How to remove the automatic braking (on power off) in the SCP1

This document applies ONLY to the first version (small retriggerable fuse) of the analog cartridge of the SCP-1, positive polarity (common ground). For later versions, a dip-switch is provided to the same effect, please refer to the most recent version of the manual.

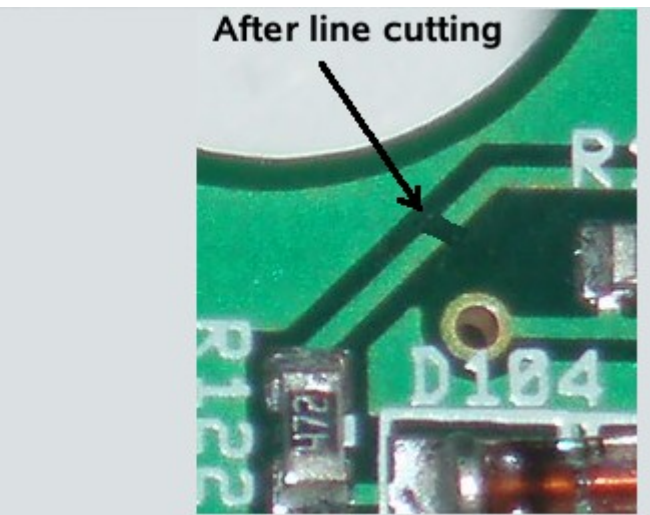
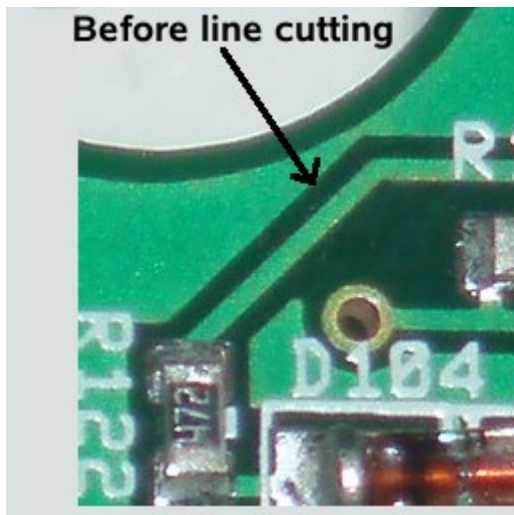
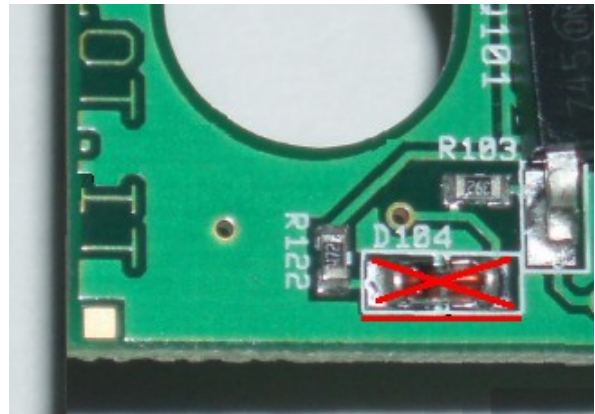
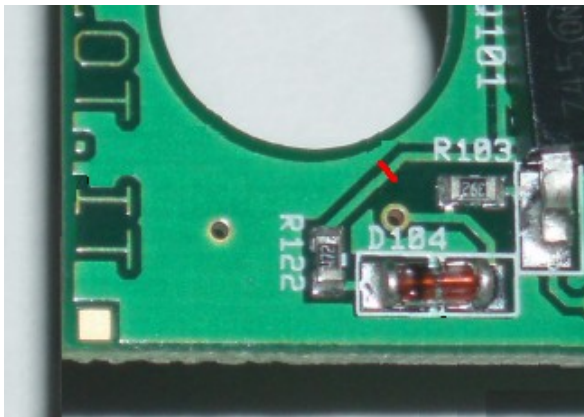
2. Cut the RED line with a cutter's edge, or, remove diode D104
